Product Change Notice

Affected model: OLED Model No. WEO128128B Series

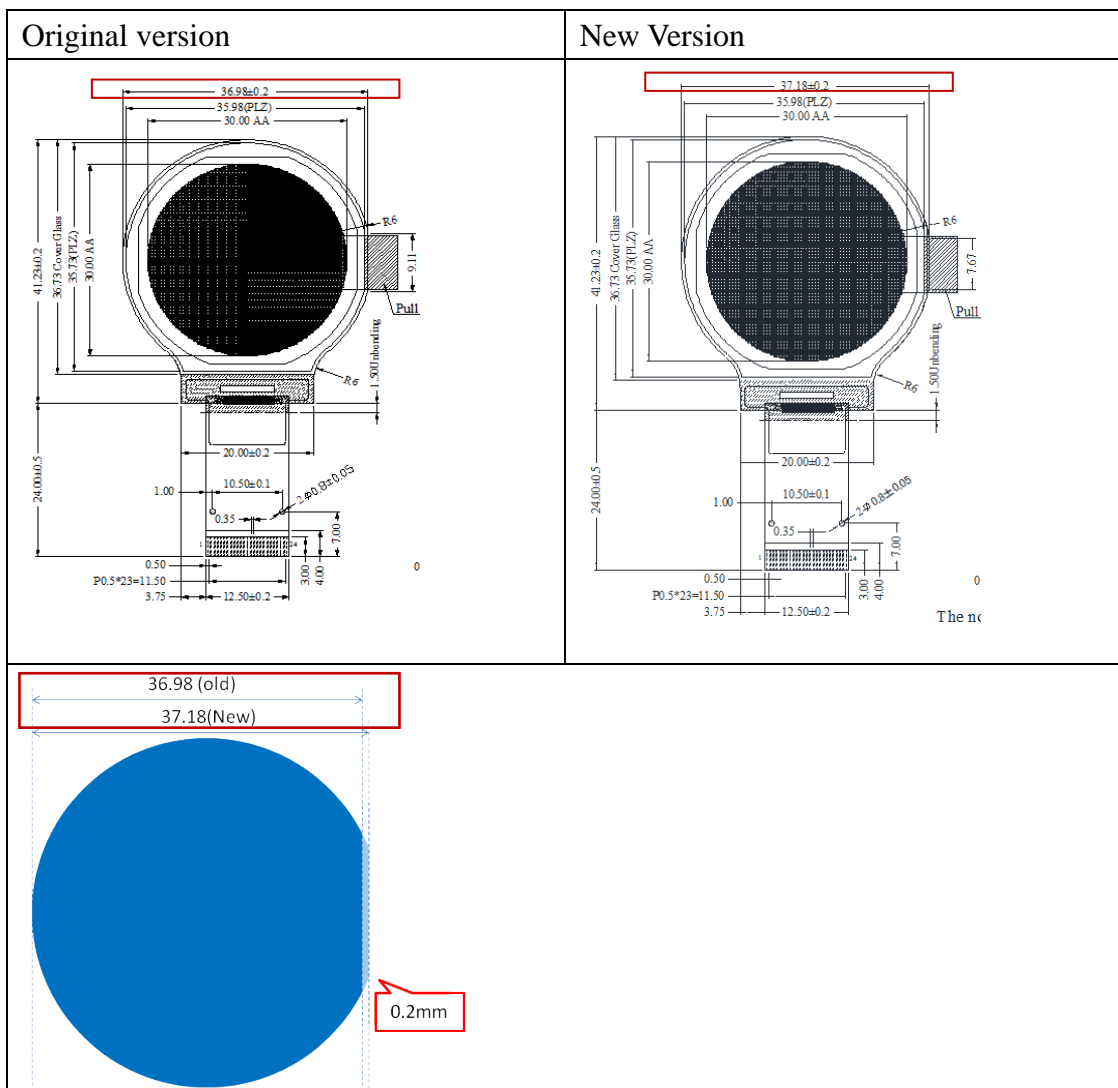
The outline dimension shown below in red is 0.2mm bigger than the original one, the function, and the electrical characteristics remain the same. Below is the module drawing comparison:
